Planning Commission
CodeNEXT Draft 3 Recommendation Report to City Council

23-1A-6020 Prioritization of Regulations Affecting Minimum Development Potential

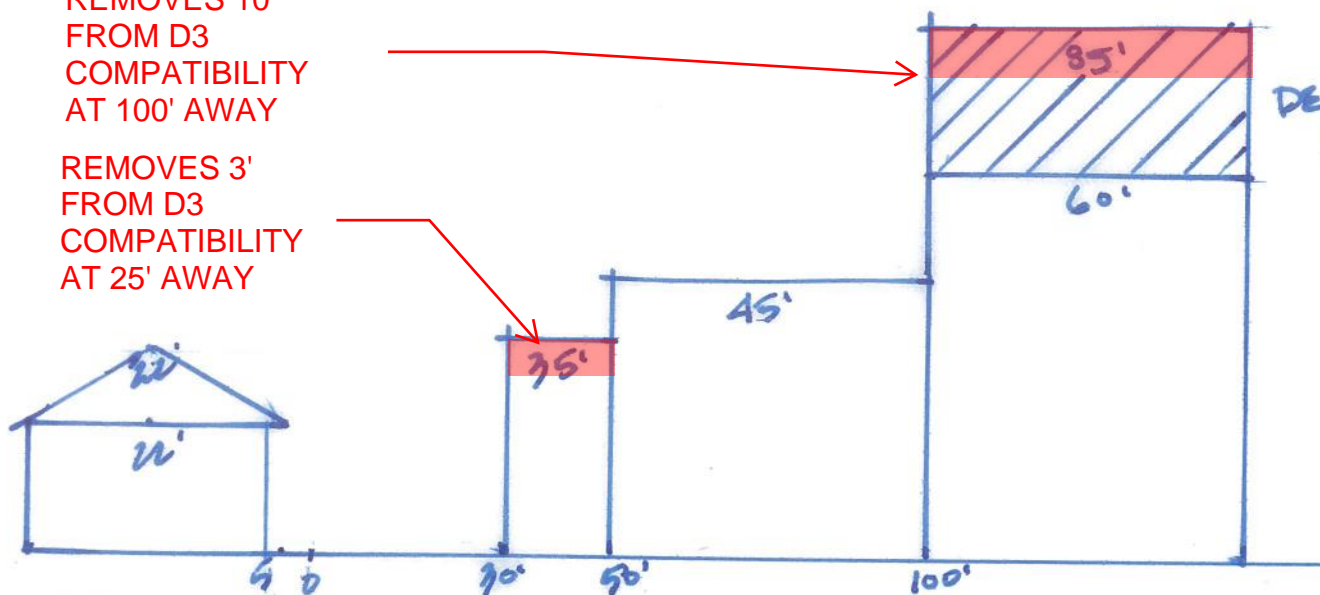
| | | | | Vote Tallies | | | Vote by Commissioner | | | | | | | | | | | General to Code, General to Chapter, Specific to Article, or Specific to Section | Section Number | Annotated PC Motion Page No. | Related Exhibit | Broad Topic | Staff Response | Original Planning Commission Motion | Related Planning Commission Motions | | |
|--------|------------------------------|--|--------|--------------|----------|----------|----------------------|------|-------|--------|---------|----------|----------|-------|----------|----------|-------|--|----------------|------------------------------|---|--------------------------------------|--|-------------------------------------|---|---------|----------|
| 7 | Original Motion | Add language to 23-1A-6010 and 2301A-6020 regarding Minimum Development Potential as shown in Steven Oliver Exhibit 1 | Passed | 7 | 5 | 1 | | | | | | | | | | | | | | | | | | | | | |

| | | | | Vote Tallies | | | Vote by Commissioner | | | | | | | | | | | General to Code, General to Chapter, Specific to Article, or Specific to Section | Section Number | Annotated PC Motion Page No. | Related Exhibit | Broad Topic | Staff Response | Original Planning Commission Motion | Related Planning Commission Motions | | |
|--------|------------------------------|--|--------|--------------|----------|----------|----------------------|------|-------|--------|---------|----------|----------|-------|----------|----------|-------|--|----------------|------------------------------|---|--------------------------------------|--|-------------------------------------|---|---------|----------|
| | Amendment to Original Motion | Add language that leaves this to the discretion of the director | Failed | 4 | 8 | 1 | | | | | | | | | | | | | | | <p>PAZ: Oppose. Amendments can be made, as needed, when conflicts are identified.</p> <p>DSD: This is a policy decision concerning the hierarchy of code requirements where the city's codes have conflicting provisions and impacts. This adds a layer of review, and is potentially more complicated and less predictable than the variance processes in Draft 3. DSD is supportive of the concept of a hierarchy of code to address regulatory conflicts that arise during the review process; however, additional policy direction is needed to determine regulatory priorities.</p> <p>WPD: Oppose. As currently worded, the amendment undermines multiple existing regulations related to the environment, water quality, and drainage, including:</p> <ul style="list-style-type: none">• Non-degradation standard of the Save Our Springs (SOS) ordinance• Stormwater management for water quality and flood risk reduction• Restrictions on development in the floodplain• Waterway setbacks for creeks and lakes• Setbacks for critical environmental features such as caves, wetlands, and springs• Tree and urban forest protections (excluding heritage trees)• Requirements for preserving floodplain health• Steep slope protections• Limitations on the depth of cut and fill• Preservation of open space and natural areas• Provision of landscape elements and vegetated setbacks <p>Many sites across the city are significantly constrained by natural features such as floodplains and steep topography. As worded, the amendment would allow for development to encroach on environmental setbacks and reduce the footprint of stormwater control measures in order to accommodate the entitled amount of impervious cover. Staff recommends upholding the current policy of reducing impervious cover entitlements as necessary to accommodate environmental features and protections. To the extent that the reasonable use of a property is eliminated, the existing variance process allows for adjustments to water quality and drainage regulations.</p> | | | | | | |

SHIEH SUBSTITUTE
MOTION

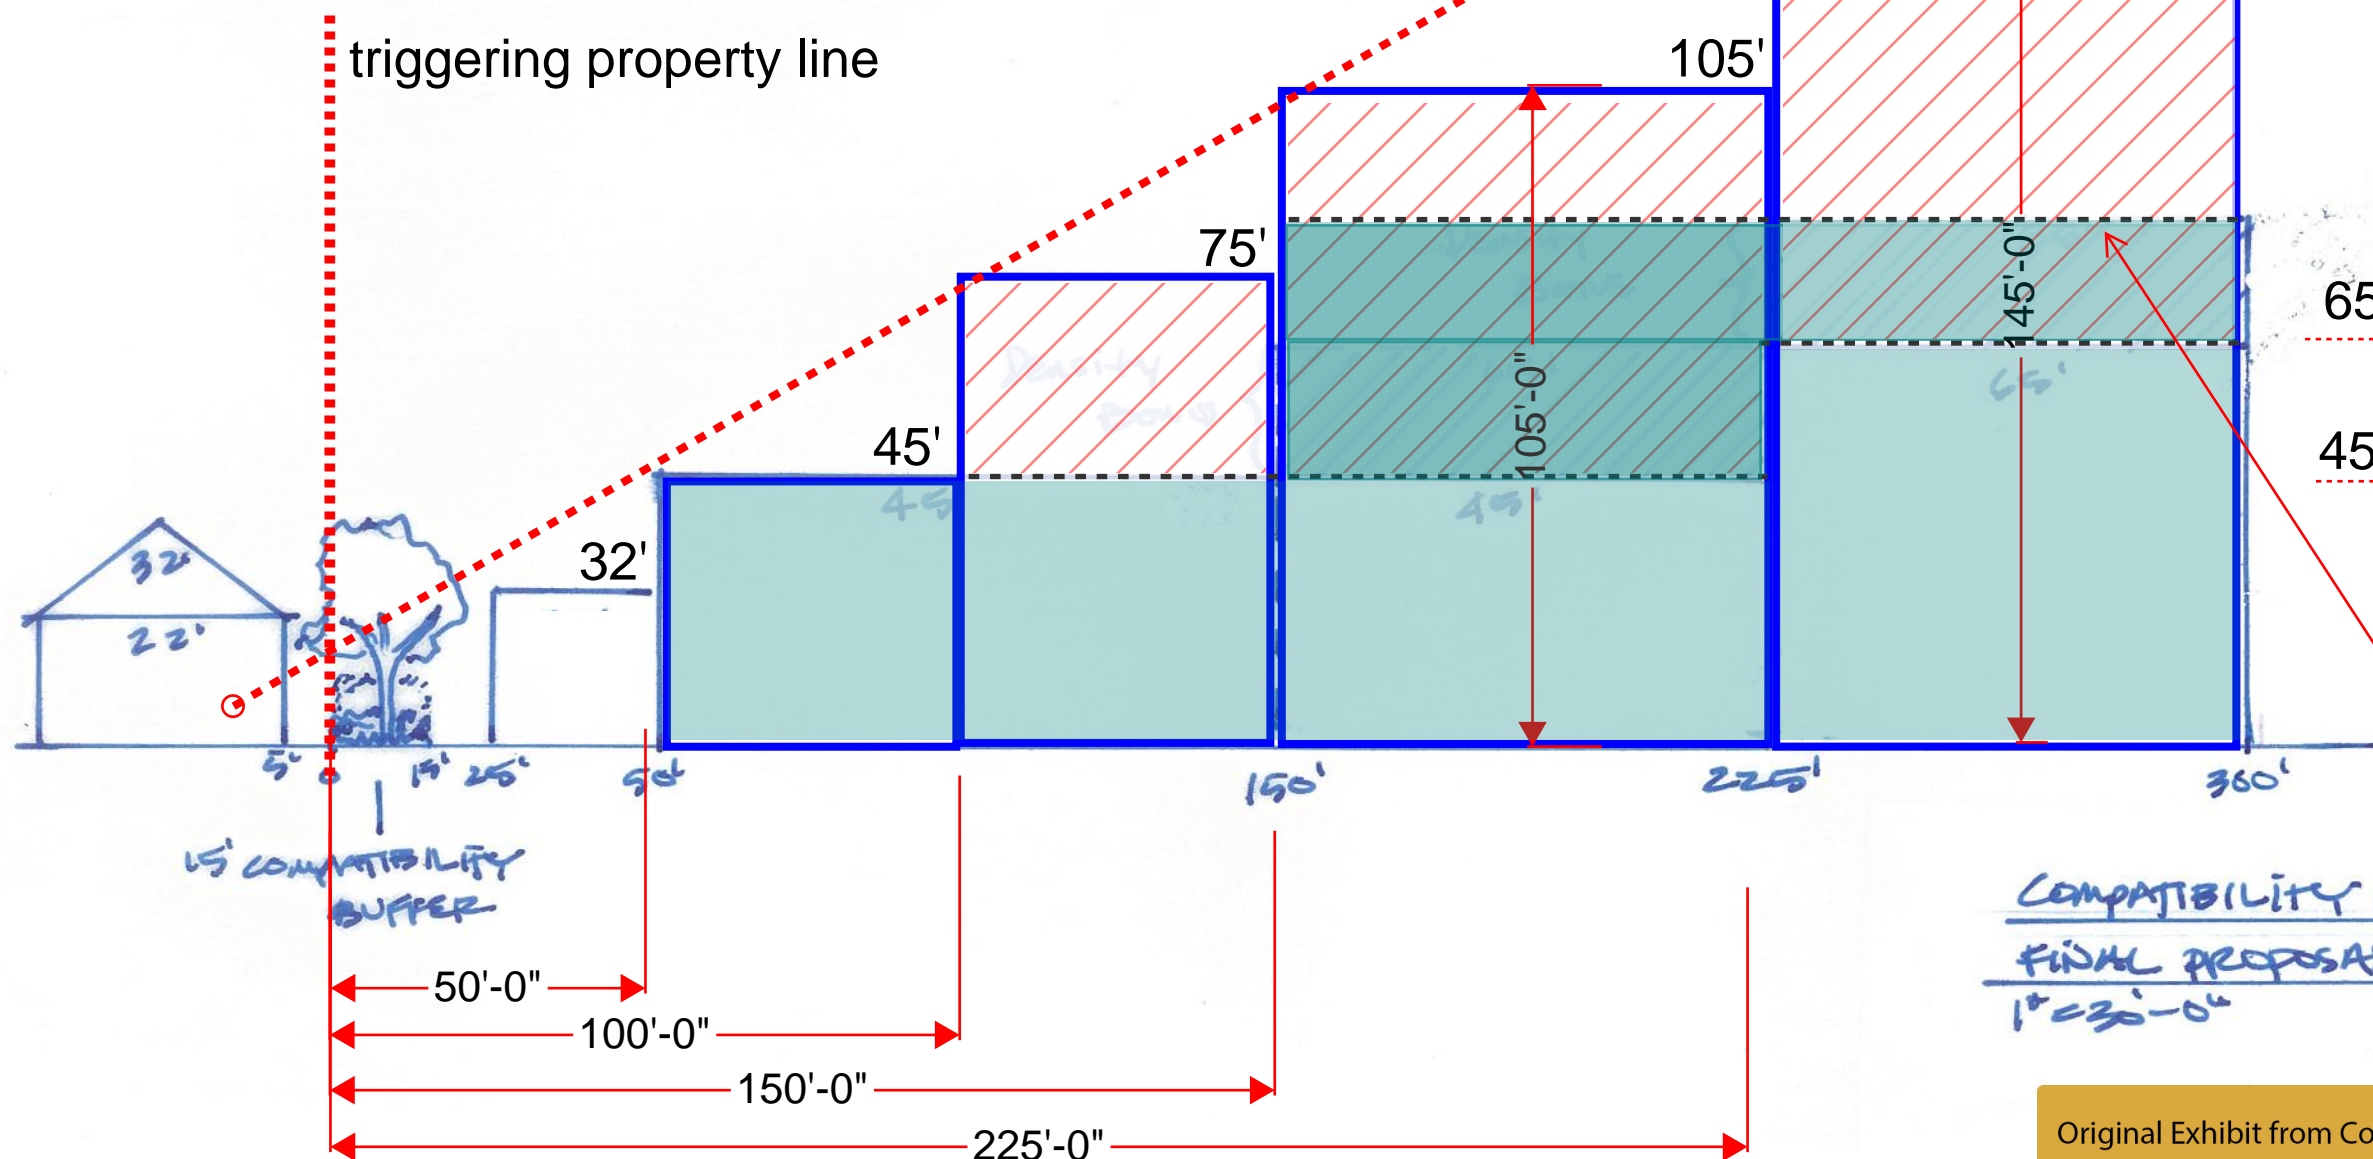
SLIGHTLY MORE
RESTRICTIVE THAN
IMPACT OF SIGHT LINE
OBSCURED BY RIGHTS
OF ANOTHER
MCMANSION

30 ANGLE FOLLOWS
LINE OF SIGHT FROM 6'
FOOT TALL AT 15'
INSIDE TRIGGERING
PROPERTY
